CH₄ exchange at the forest floor of a forestry-drained fen: low flux rates but high temporal variation by Korkiakoski et al.

Response to reviewer #2

Figure 2A. Concentration data during one chamber closure for a case with a higher (left: linear and exponential: -90 and $104 \mu\text{g CH}_4 \text{ m}^{-2} \text{ h}^{-1}$, respectively) and lower (right: lin -3.5 , exp $-4.3 \mu\text{g CH}_4 \text{ m}^{-2} \text{ h}^{-1}$) flux.

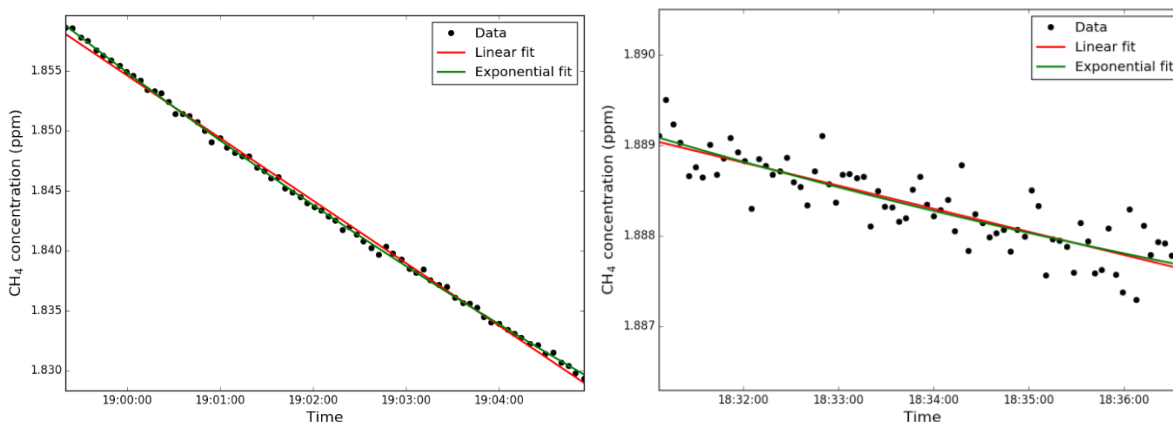
Still having in mind very low magnitude of the fluxes, I would ask the authors to add, either in the main paper or in the supplementary material, a figure with two typical examples of concentration data during flux measurements – one with a high flux (over $3.5 \mu\text{g CH}_4 \text{ m}^{-2} \text{ h}^{-1}$), and one with a low flux – with lines for the linear and the exponential approximation over each. That will be a very sensible for the reader illustration of the measurement precision, signal-to-noise ratios, etc.

7. Figures of concentration data of ‘high’ and ‘low’ flux cases have been added to the revised version of the manuscript (see also answer #25 for referee 1).
